RE: *Method 2B Application, Endicott Biofuels II, LLC, Palm Fatty Acid Distillates to Biodiesel (BIOD012)*

Comments on *Method 2B Application, Endicott Biofuels II, LLC, Palm Fatty Acid Distillates to Biodiesel (BIOD012)*

Comparison of market prices of vegetable oils
(US\$/tonne, left axis) and price ratios (right axis)

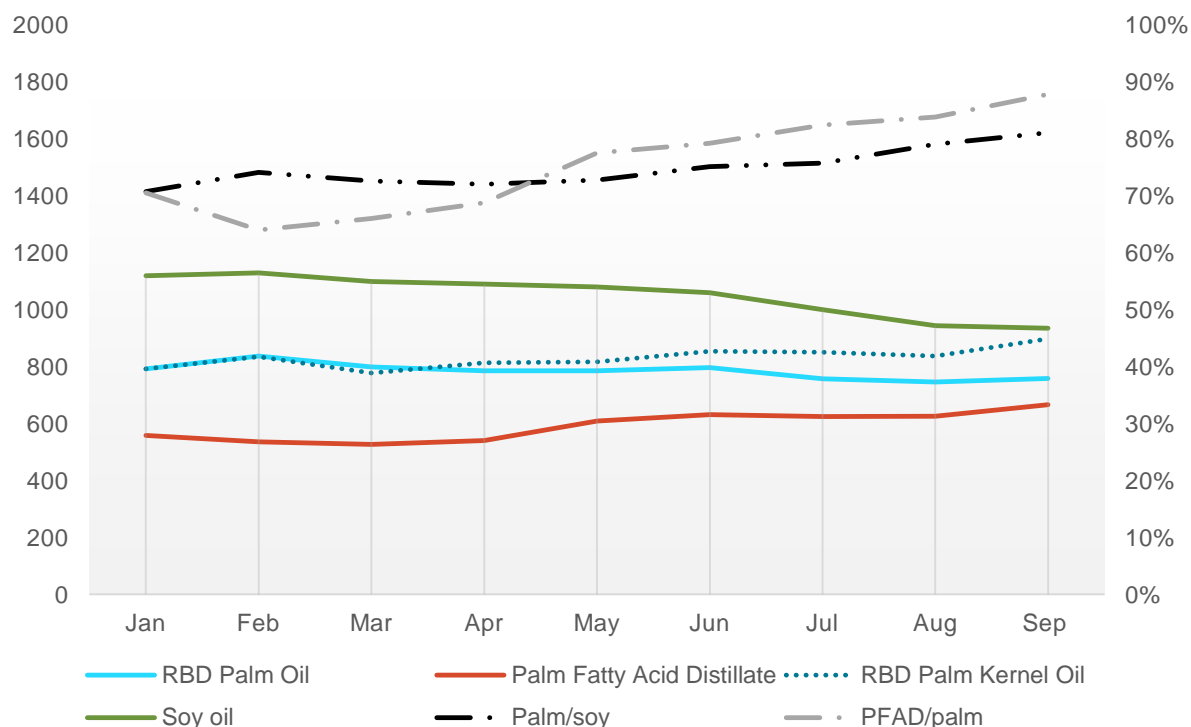
The staff report identifies PFAD as “a low-value byproduct of the palm oil production process.” While it is indeed a byproduct, we believe that referring to PFAD as low-value understates its market value. Indeed, PFAD generally trades at about 80% of the value of palm oil, and is thus in a similar market position compared to palm as palm in compared to soy. The chart below compares reported market prices for soy oil, palm oil, palm kernel oil and PFAD from January to September 2013, and also shows the ratios of PFAD to palm oil price, and palm oil to soy oil price. Based on market price, if PFAD is to be categorized as low value then one could argue that palm oil itself should be categorized as low value as well. Instead, it should be acknowledged that vegetable oils are high value products, and that even as a byproduct PFAD is a high value material. This matches the finding by Ecofys that PFAD has a value per tonne close to that of palm oil, and significantly over the 15% value threshold that they set for distinguishing co-products from residues.
